**ADDENDUM No. 3**  
**Request for Competitive Sealed Proposals (CSP)**  
**19CSP134 HVAC Services at Austin High School**

**June 24, 2019**

**Item 1: Questions and Answers**

M-FP-01

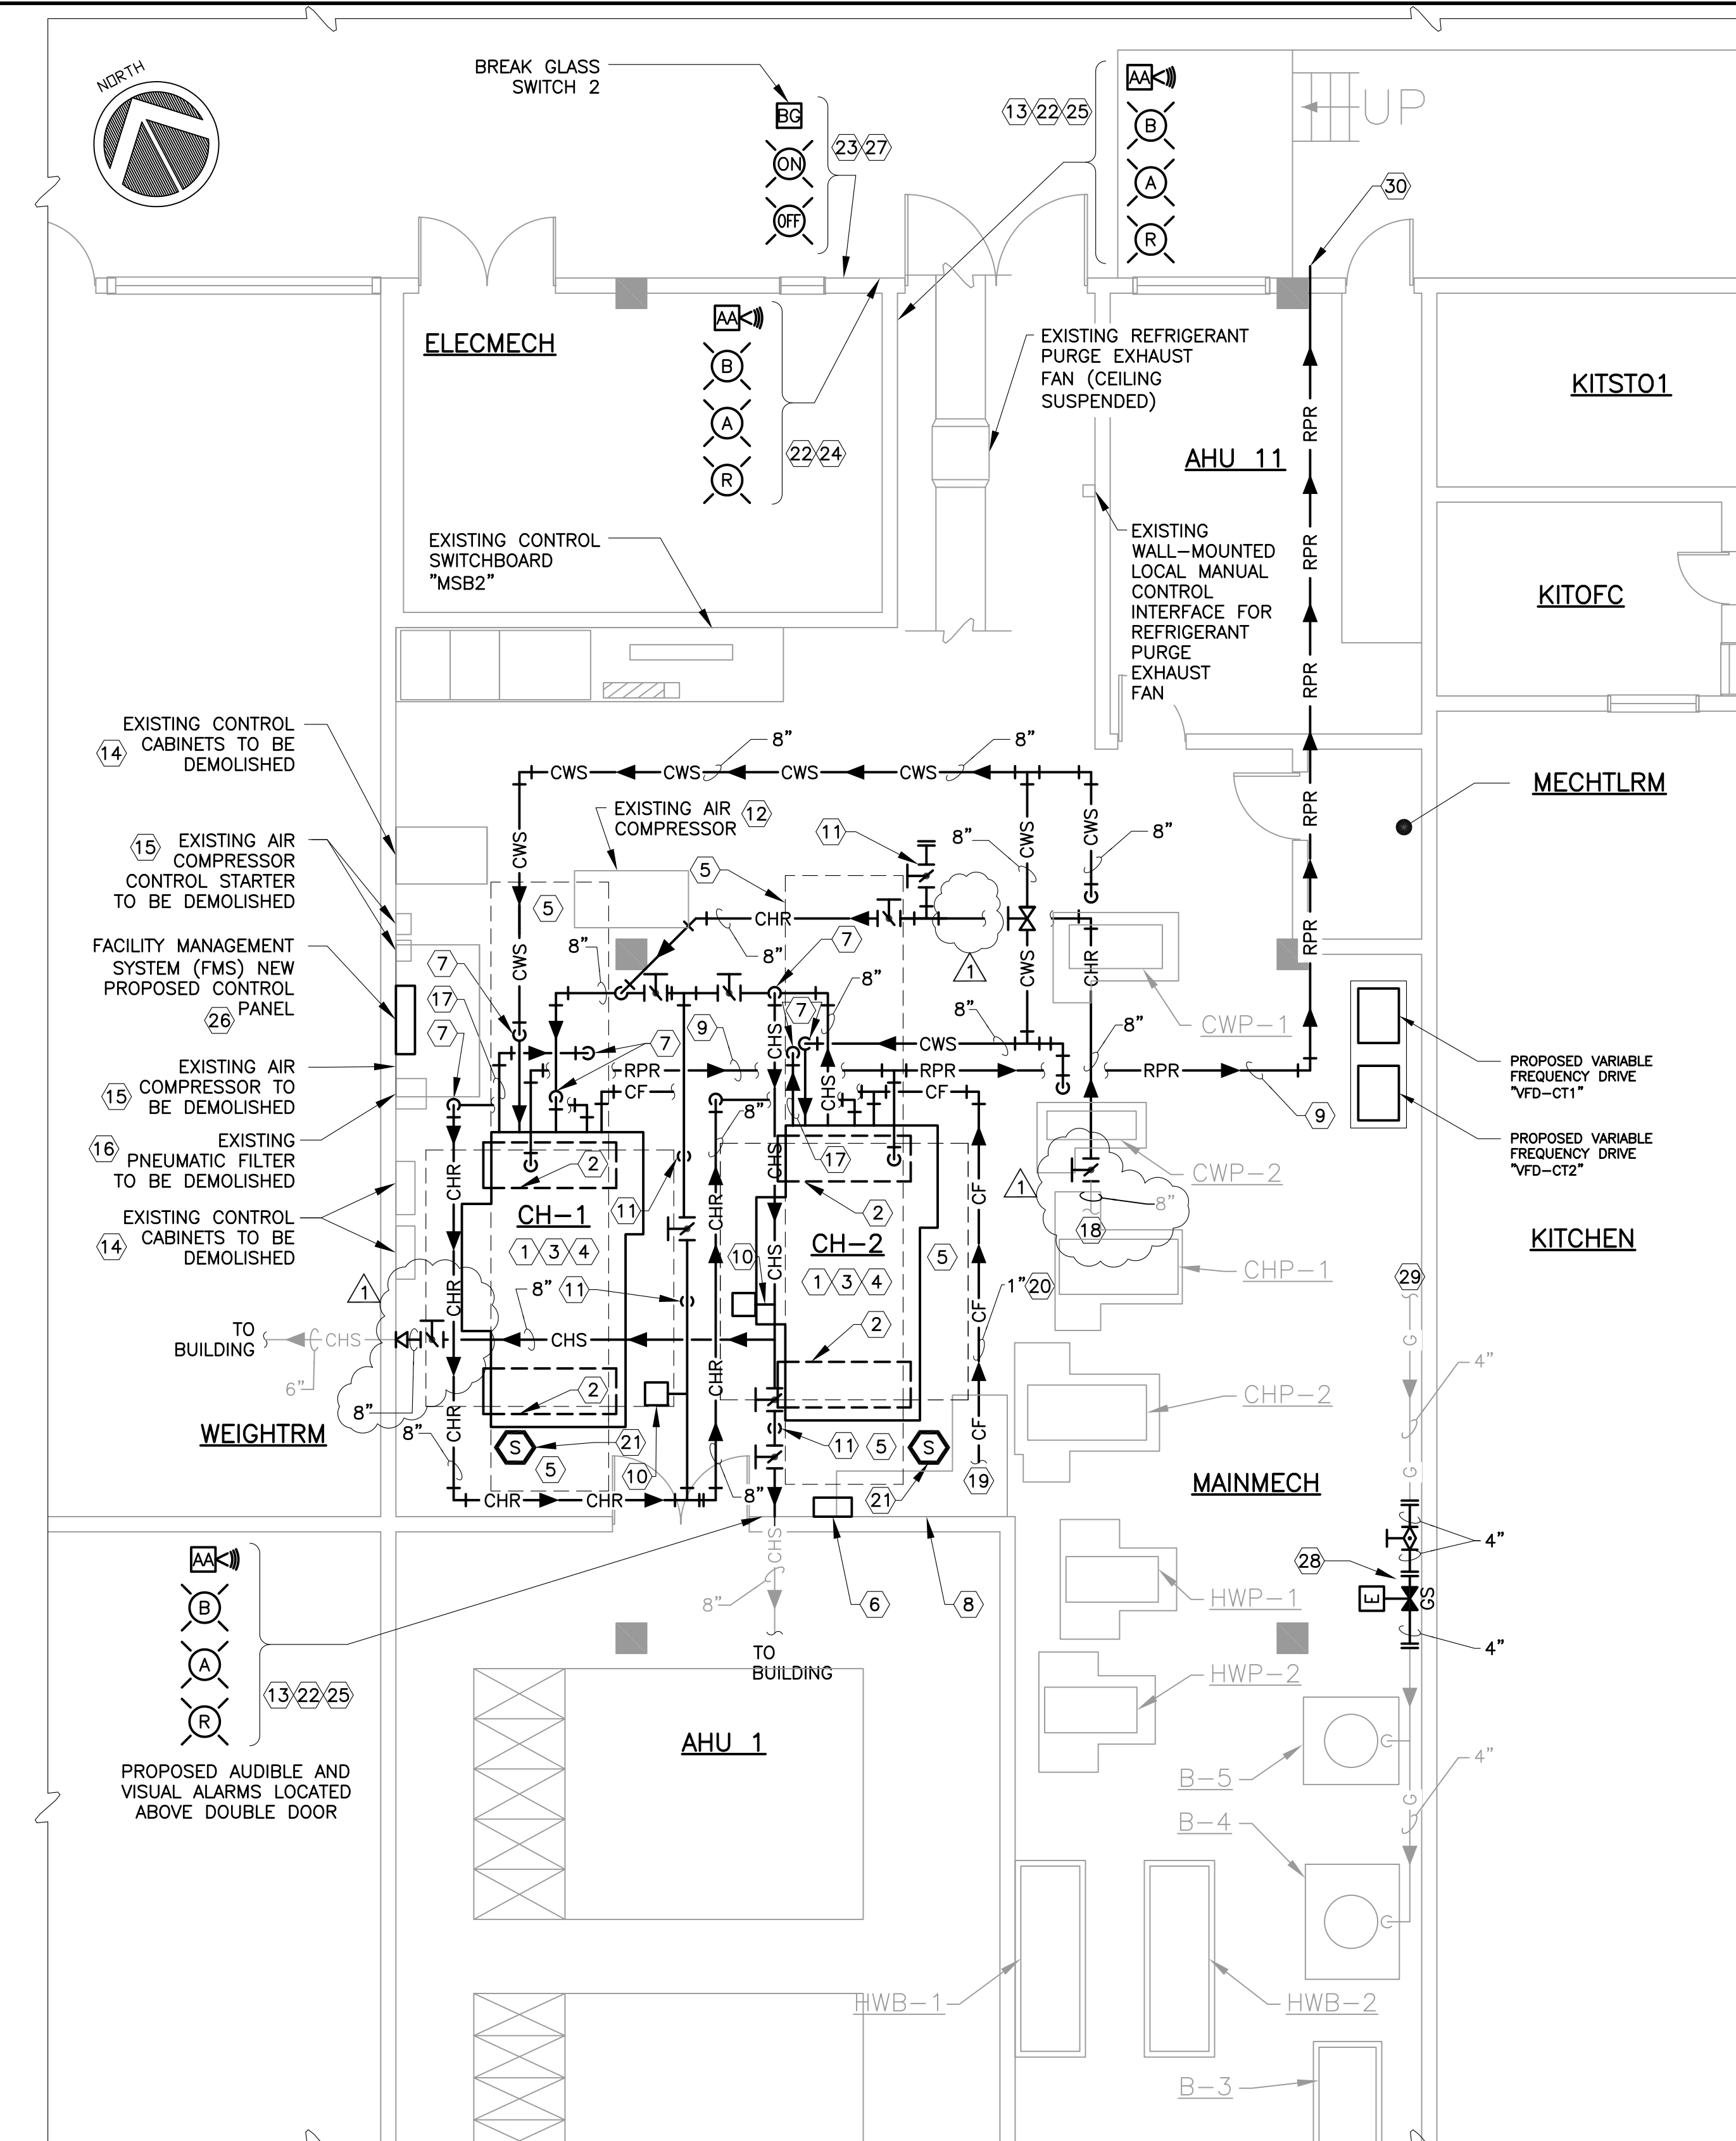
3. 1M-FP-01 Mechanical (Chiller) Room: Please issue sectional drawings looking North, South, East and West.

19. Drawing M-FP-01 and Drawing M-PSC-01 appears to depict all new piping drawn in bold is piping that is to be replaced.

**Please verify that all piping and valves, drawn in bold in the afore-referenced drawings, are indeed required to be new for both the CHW and the condenser water systems.**

**RESPONSE: Please refer to the attached Addendum No. 3 document prepared by the Engineer. Please refer to the section entitled “MECHANICAL DRAWINGS” under Article 1.01 “GENERAL CLARIFICATIONS”. Plan drawings are included of the mechanical room area. The Contractor is required to develop shop drawings during Construction as part of the submittal process.**

**RESPONSE: Please refer to the attached Addendum No. 3 document prepared by the Engineer. Please refer to the section entitled “NEW PROPOSED PIPING” under Article 1.01 “GENERAL CLARIFICATIONS”.**

1. Please refer to the mechanical drawings for the installation of connections points in the chilled water piping near the chillers for the connection of temporary chillers. Please refer to sheet M-FP-01 Key Note #11 and M-PSC-01 Key Note #13.
2. The temporary chilled water system connection points shall require a shutdown of the chilled water system and therefore is a time restricted activity. Please refer to the attached revised Sheet G-GEN-02 for additional requirements of when time restricted activities may be performed.
